DarkSide - DataManager - Ethernet

Revision	Drawing #:	TRIUMF	
0	Sheet #: 4 of 10	Size: B	4004 Wesbrook Mall
Drawn by: *	Date: 2023-04-18	V6T 2A3	Vancouver, B.C.
File: C:\Work\Dark Side 20k\rev0\Altium\DS-DM-Ethernet.SchDoc		06:43:37 PM

Gigabit Ethernet Port 0

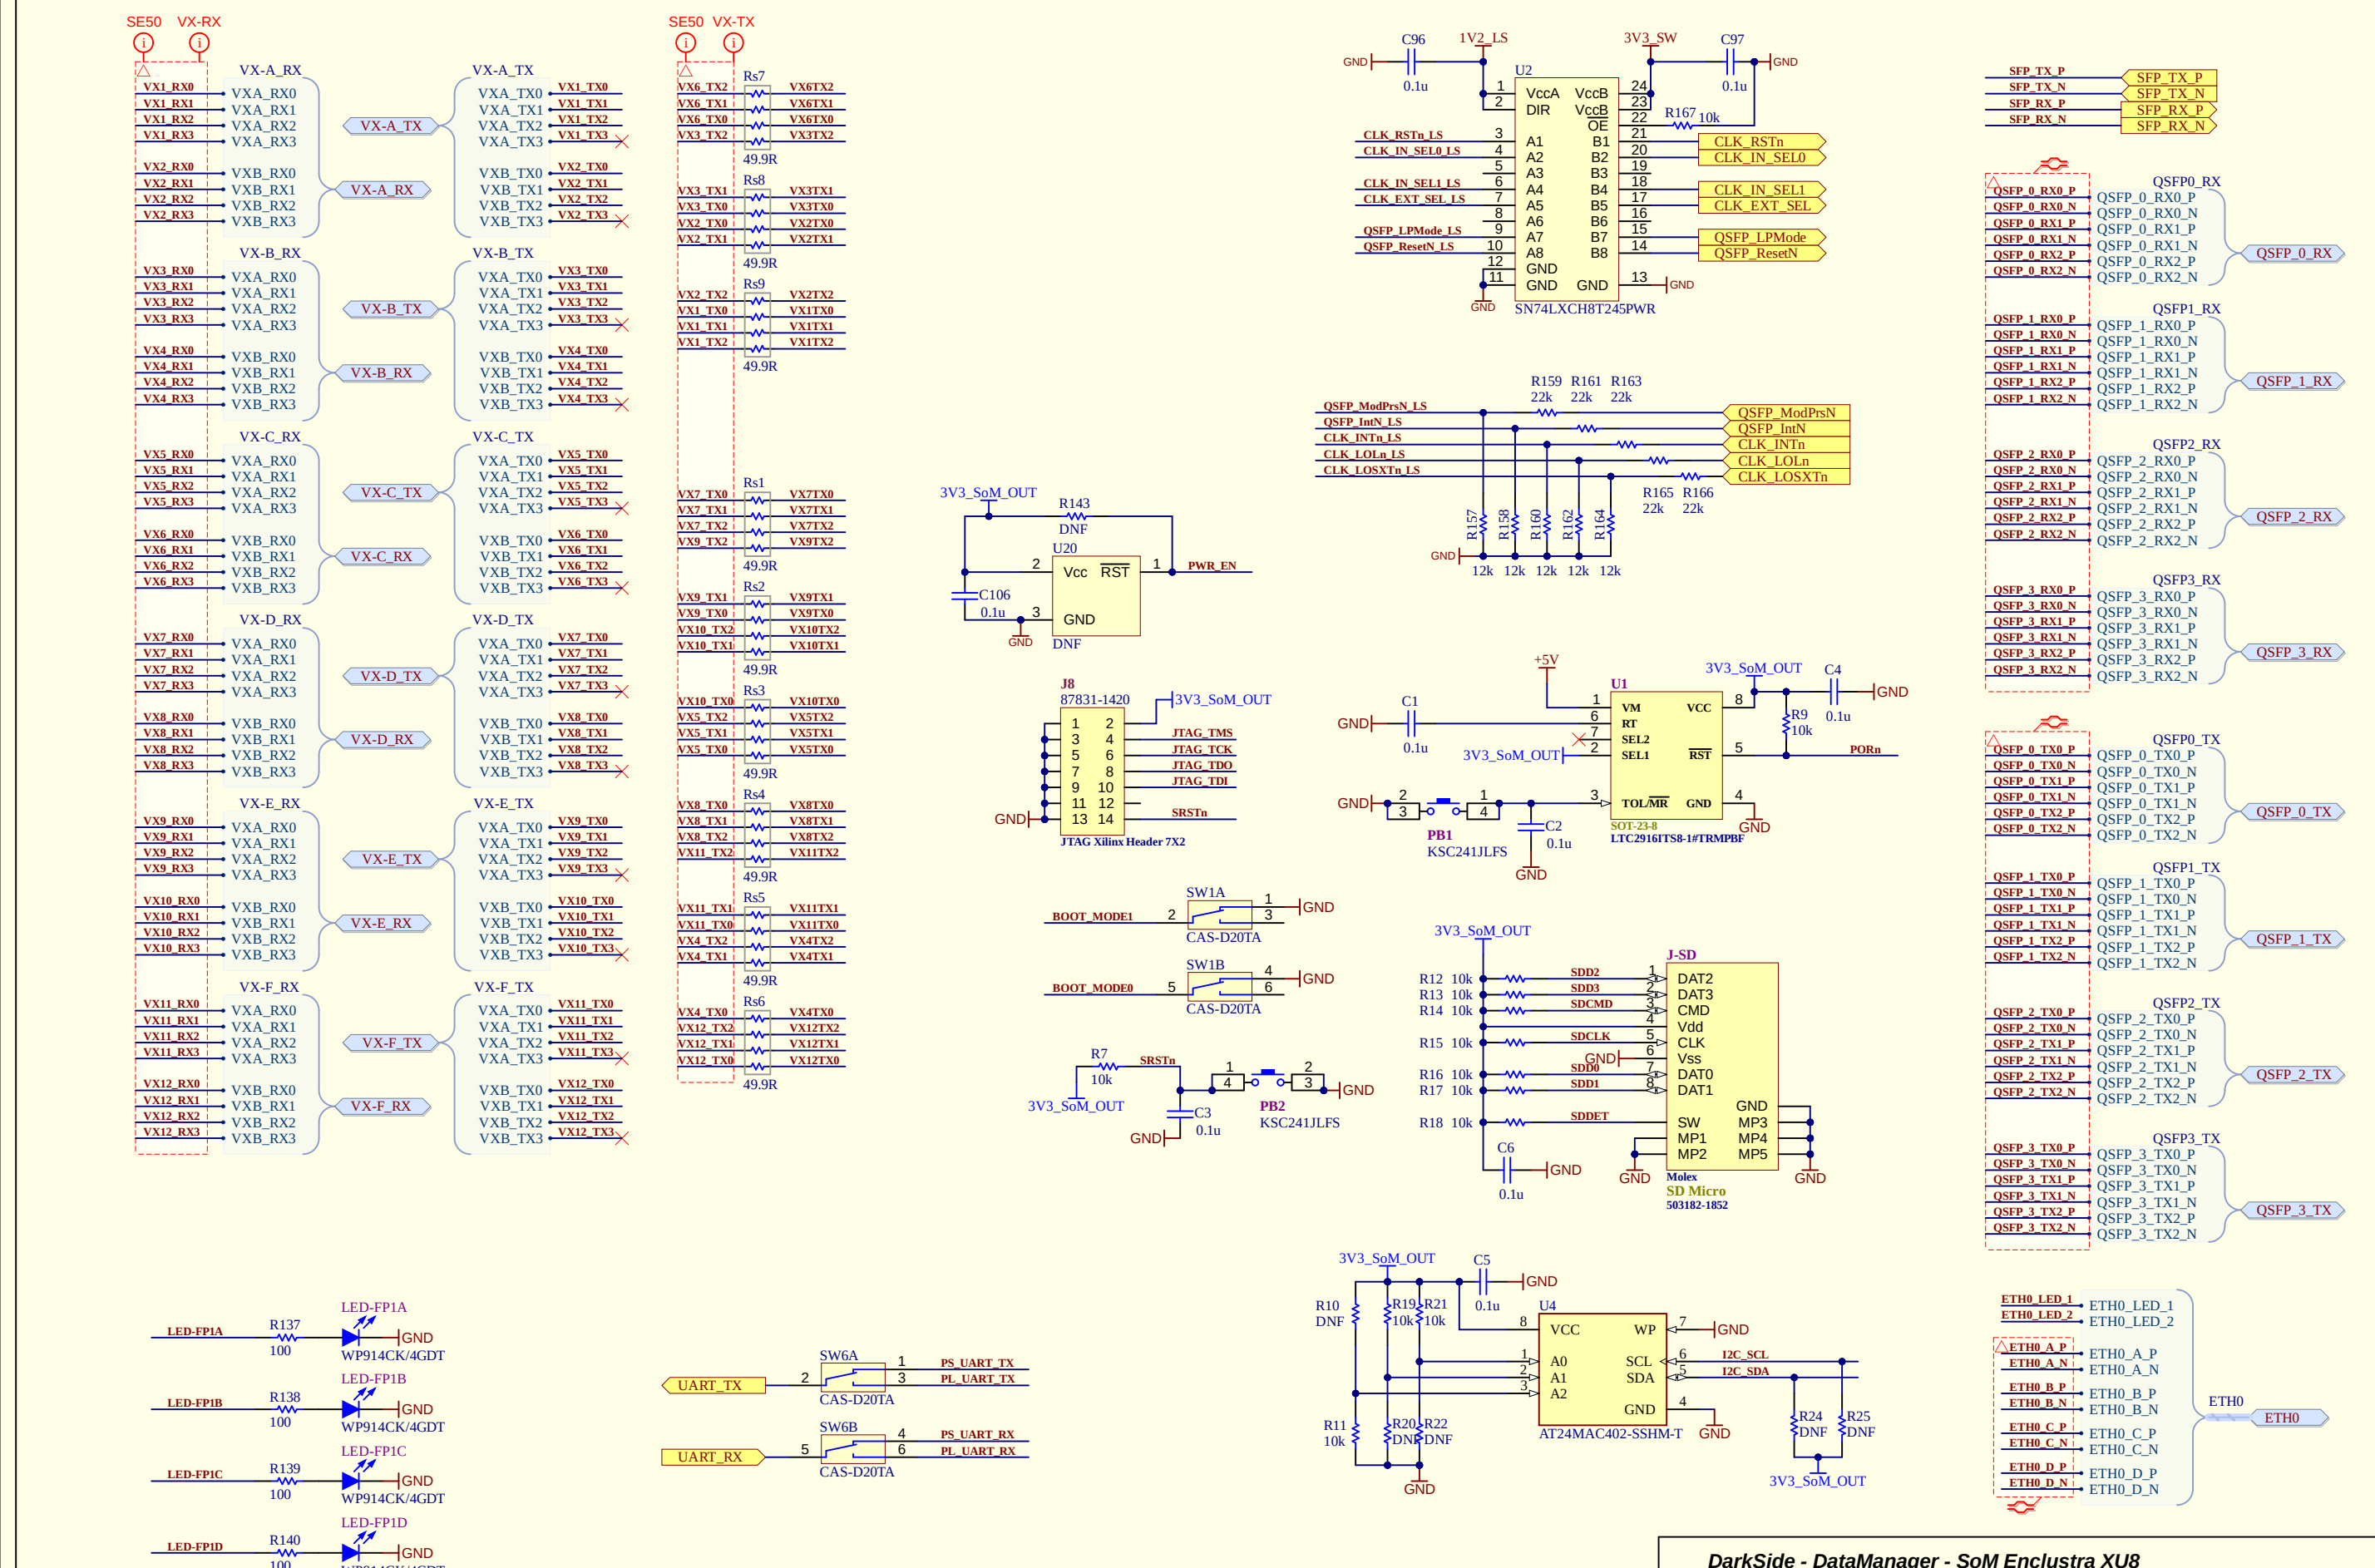
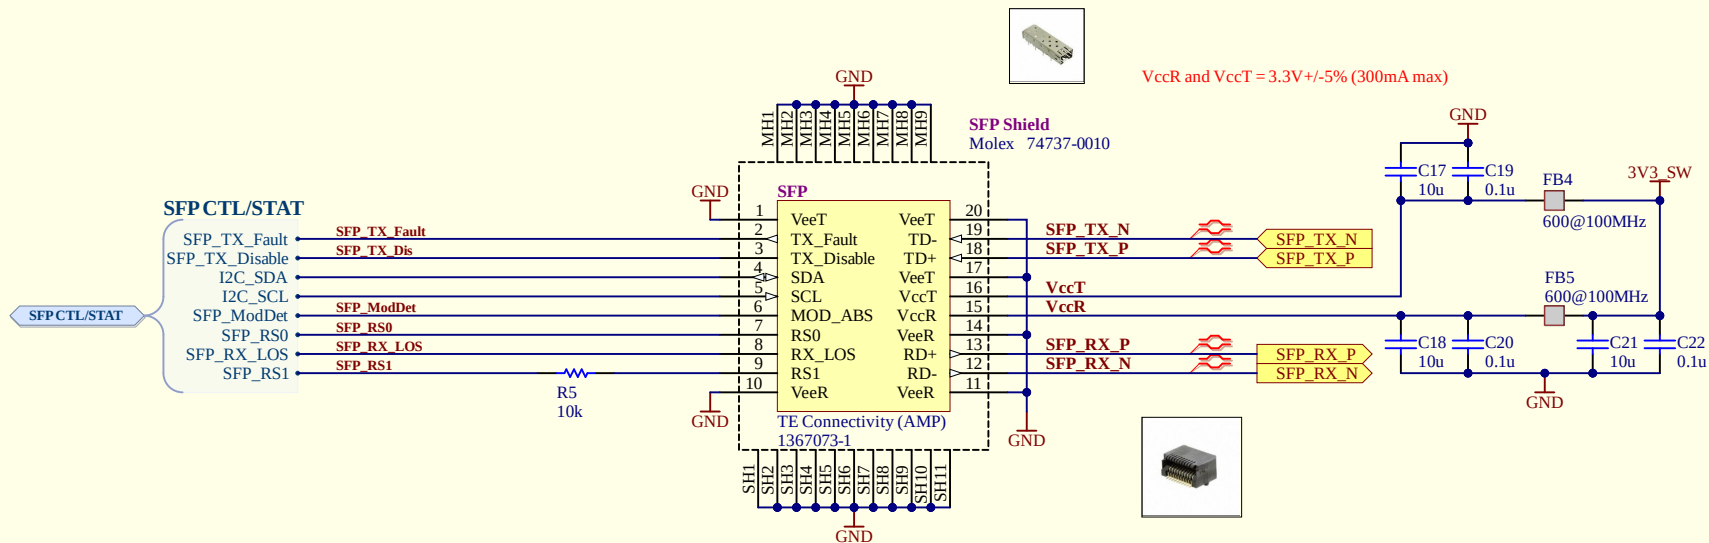
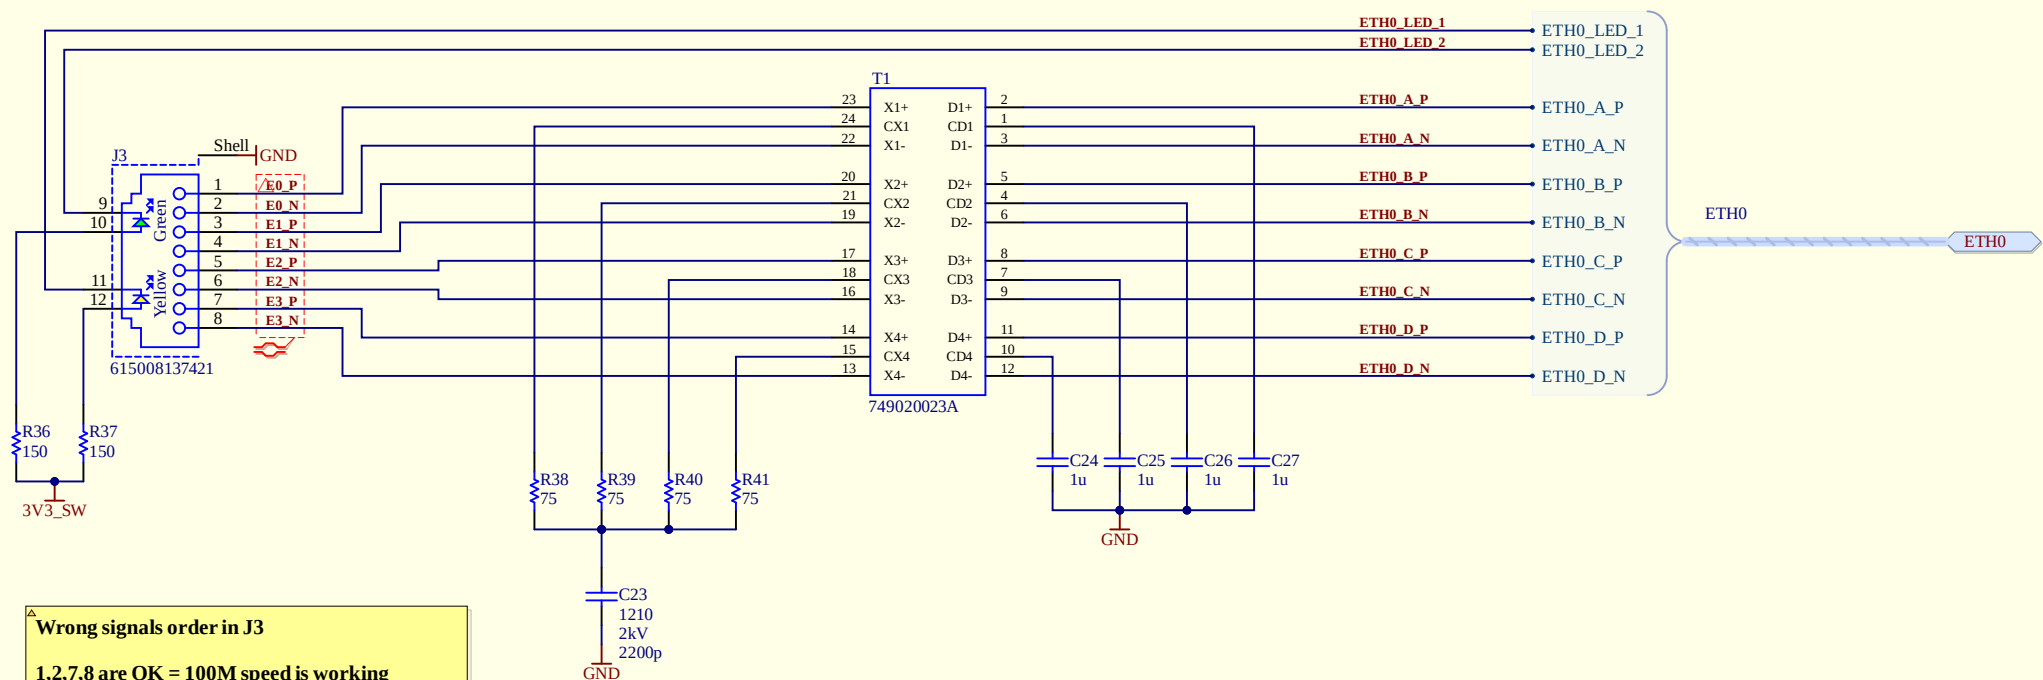
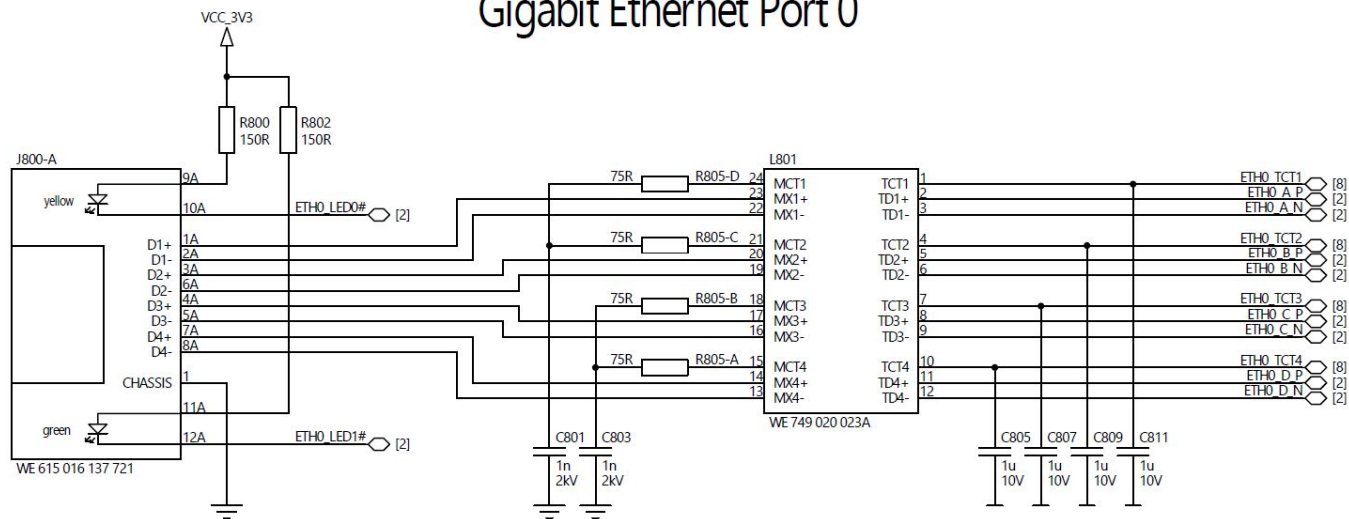
Wrong signals order in J3

1,2,7,8 are OK = 100M speed is working
3 is OK
4,5,6 must be reordered - see picture in xls for notes for REV1

HW rework possible - done on SN6
Other SNx - use special CAT5e cable
